## Design Review Subcommittee (DRSC)

Meeting Date: May 12, 2021

**SUBJECT:** Master Project 21-002, Project Summer, APNs 688-151-03 and 688-151-04, a request to develop a 104,947 square foot e-commerce delivery station with a delivery van queuing area and parking storage for fleet automobiles and vans in the Rancho San Clemente Business Park.

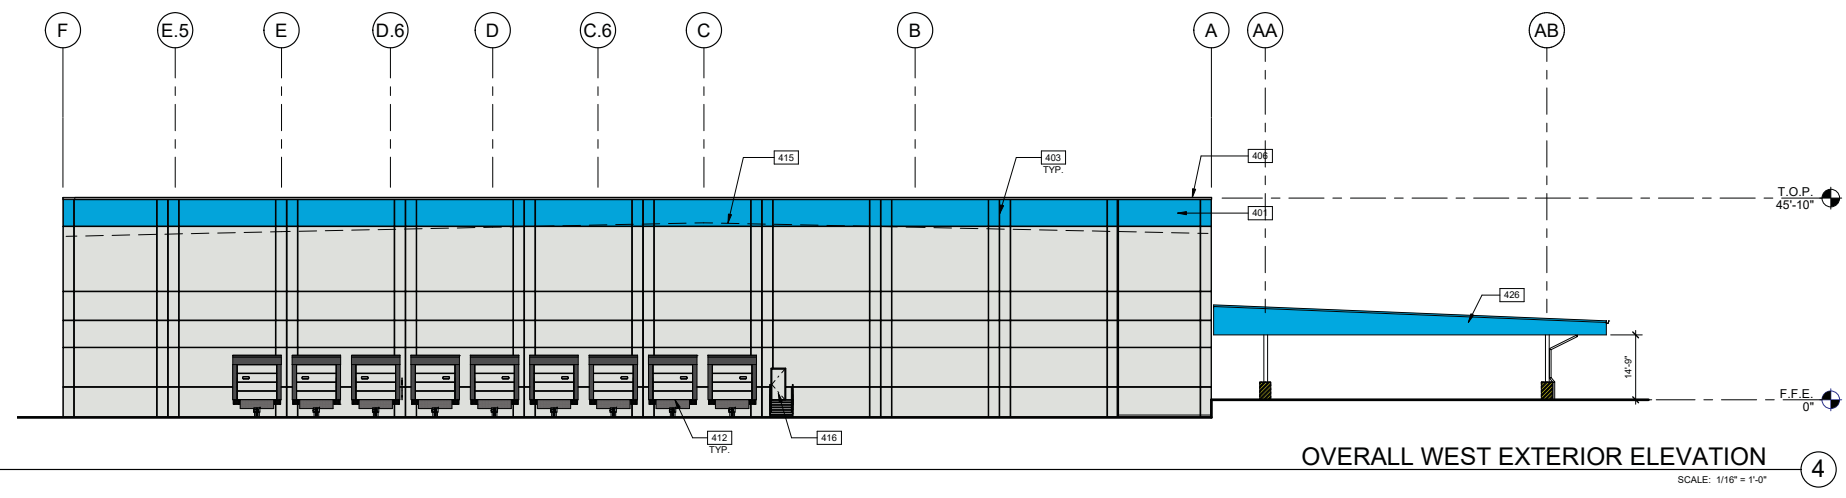
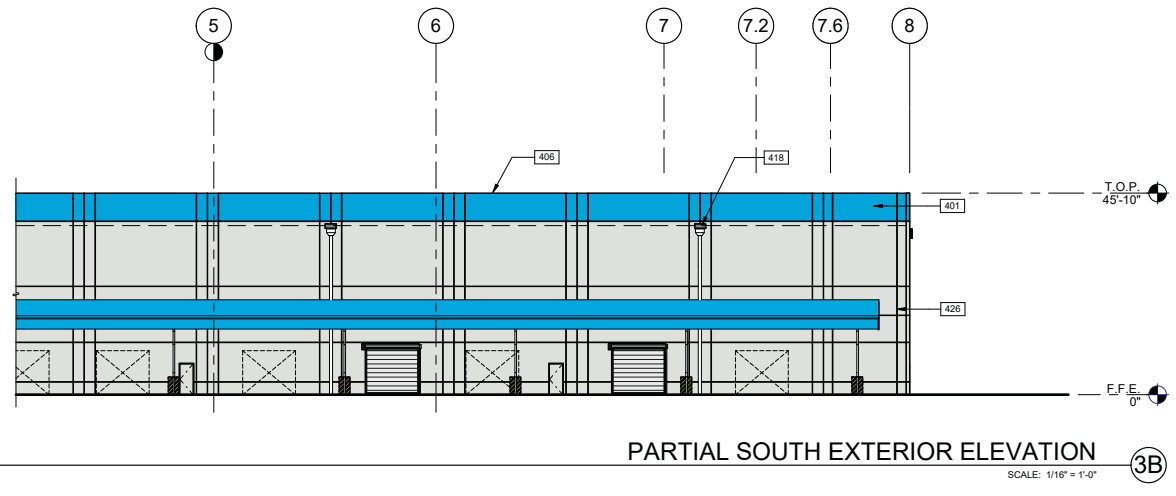
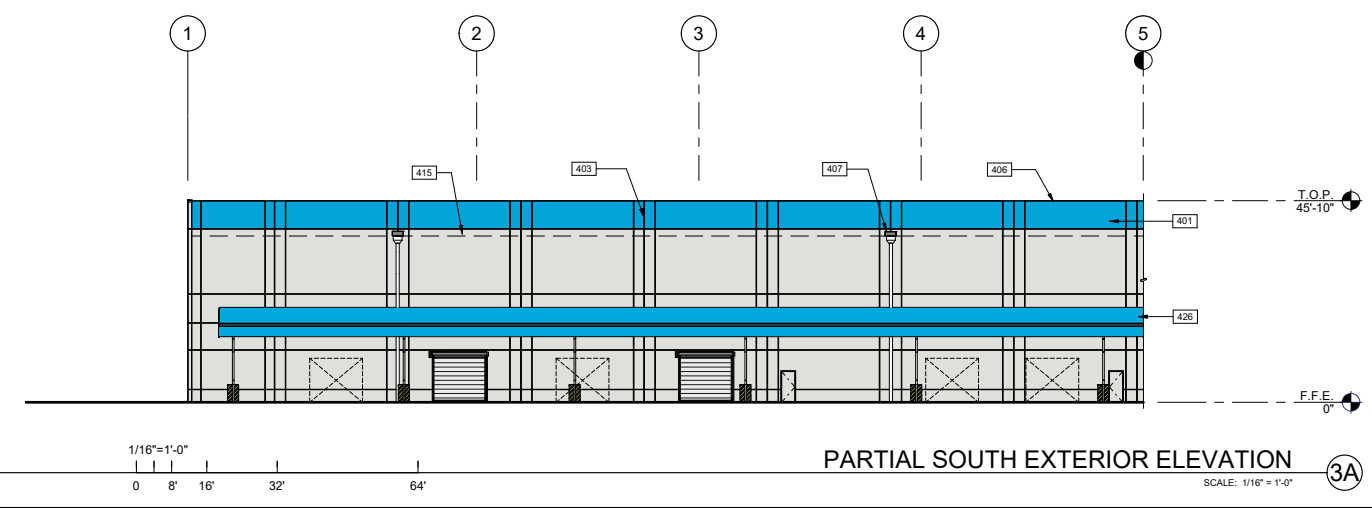
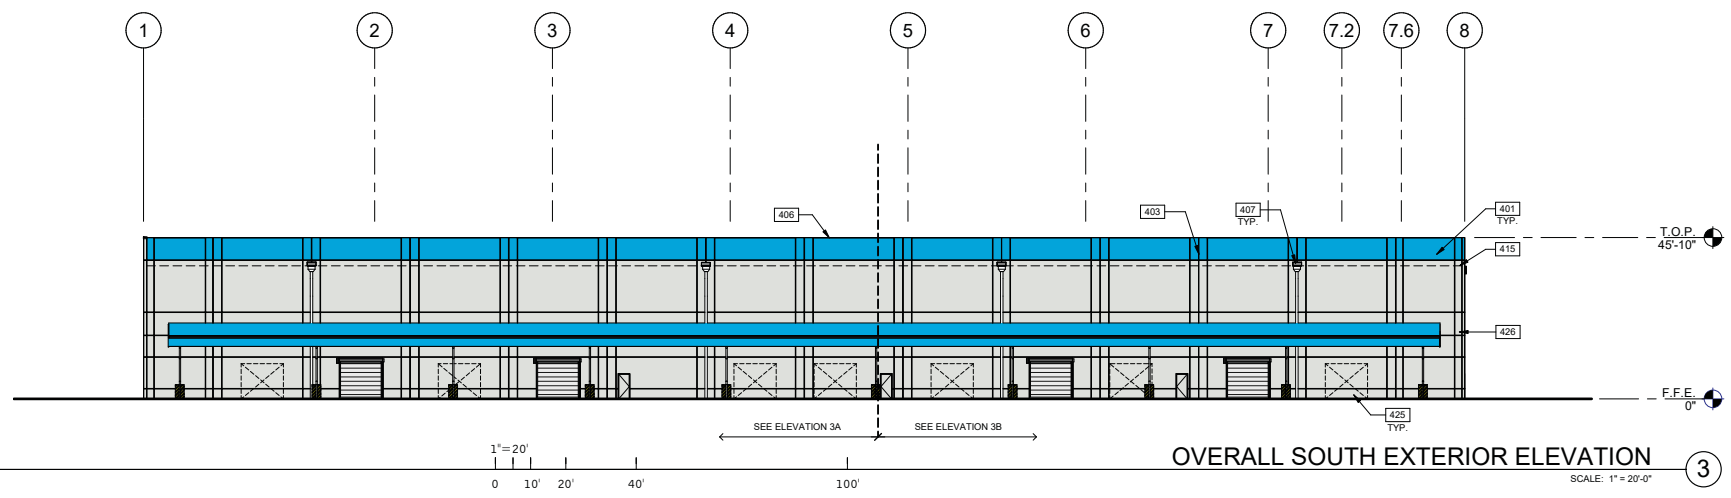
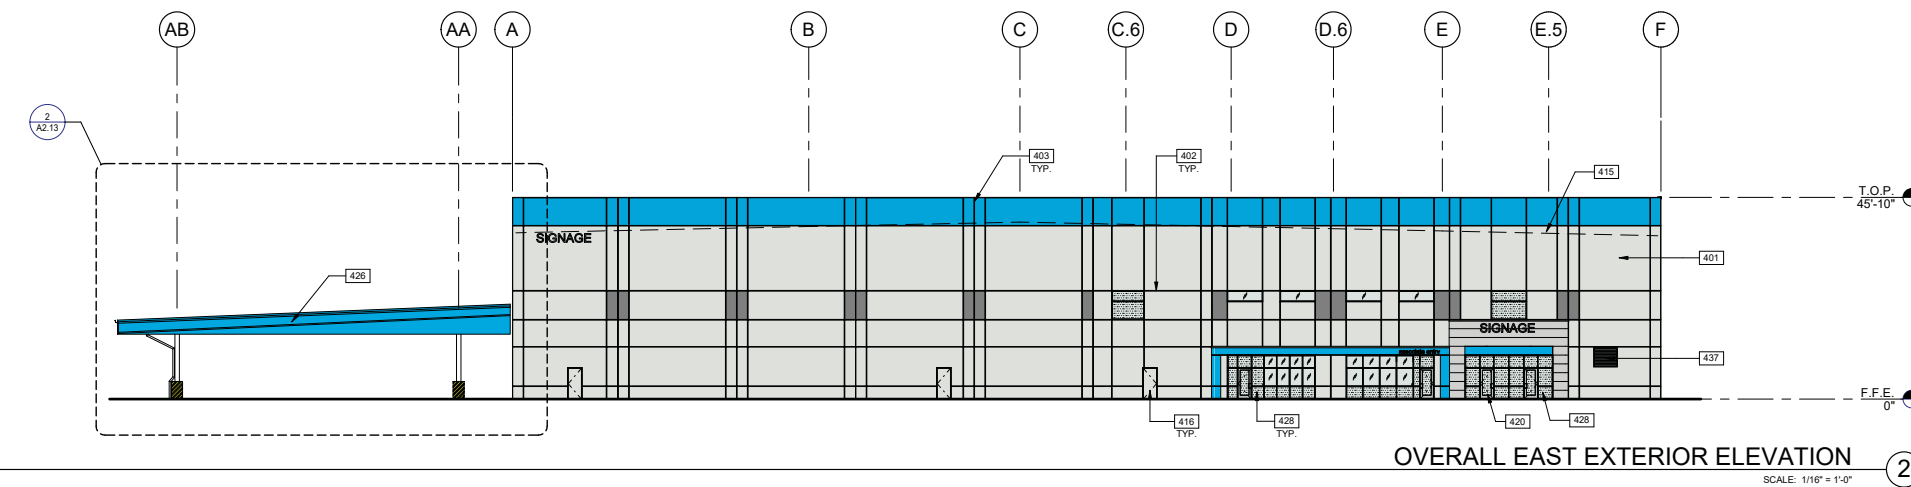
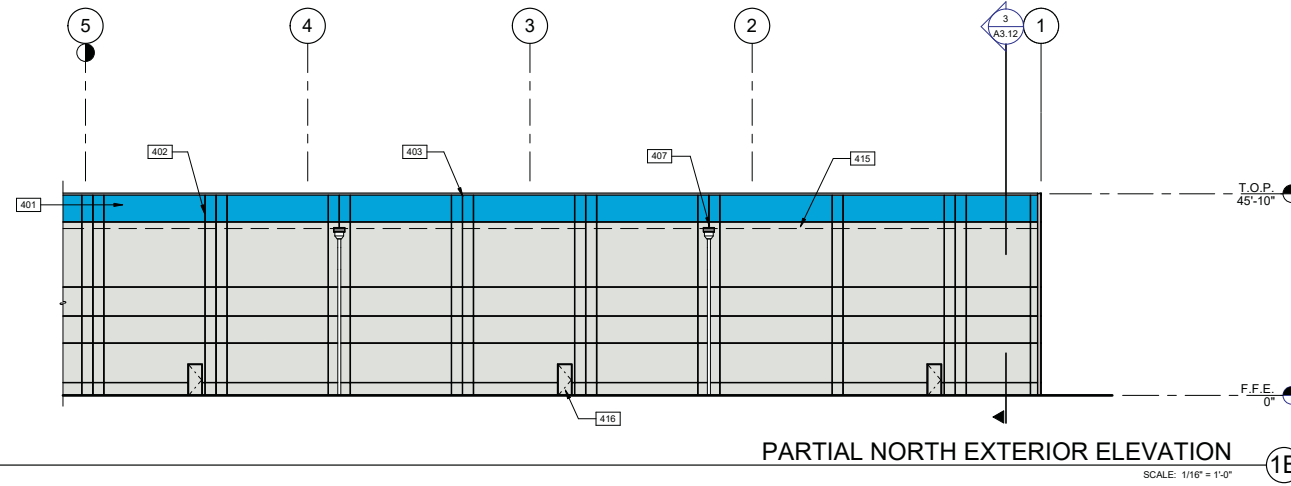
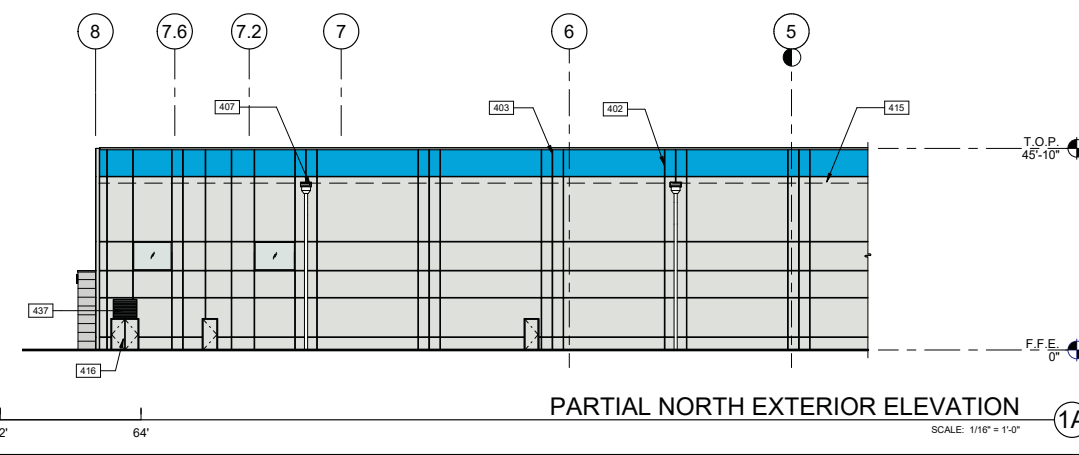
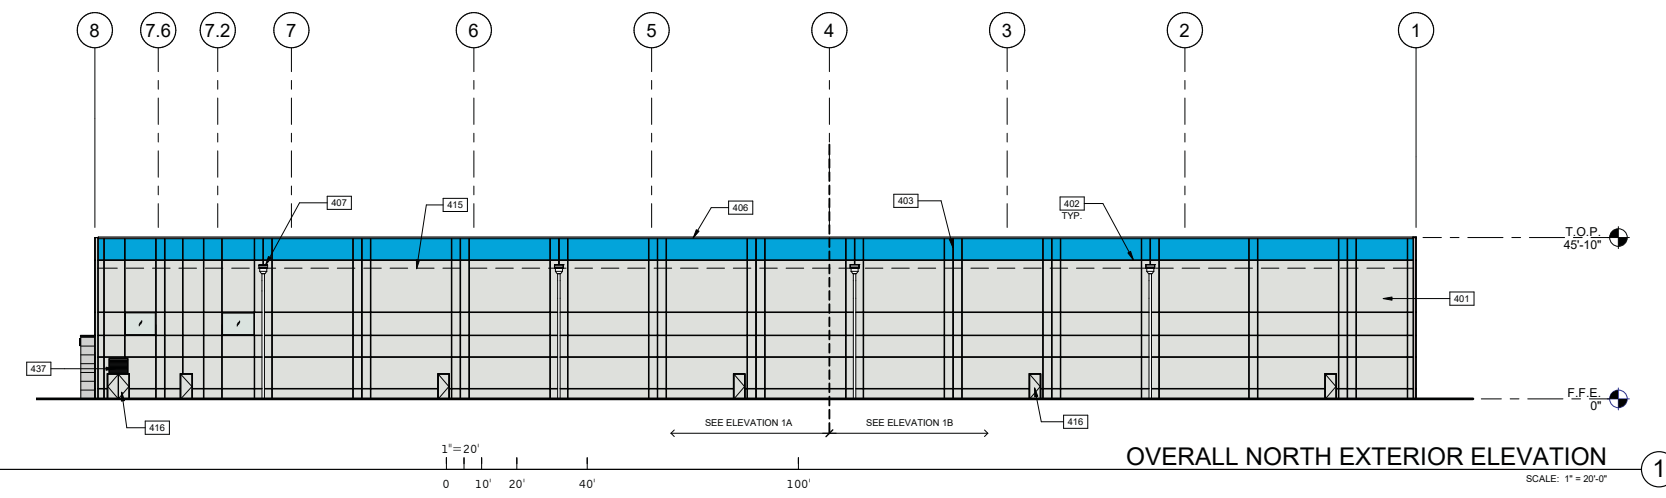
With the exception of building height, the proposed project complies with all development standards of the Zoning Ordinance and Rancho San Clemente Specific Plan. The maximum building height for the Business Park zoning district is 35 feet. The roof height slightly exceeds that, and the top of parapet is 45 feet. However, the Specific Plan allows for administrative adjustments. Specifically, it states: "In order to foster design creativity and innovation, the Planning Division may grant administrative adjustments to the standards." The applicant intends to provide additional justification to support their adjustment request. The proposed building and parapet height will be evaluated as part of the discretionary review process, but at this time, there is insufficient information to assess it during this current review.

1. Submit renderings from key public vantage points, including from the Rancho San Clemente public trail. The Subcommittee may request specific perspectives.
2. Provide a photometric study and lighting details to demonstrate the project is consistent with the City's Dark Skies policies.
3. Provide a separate Master Sign Program with additional detail on all proposed monument and wall signage.
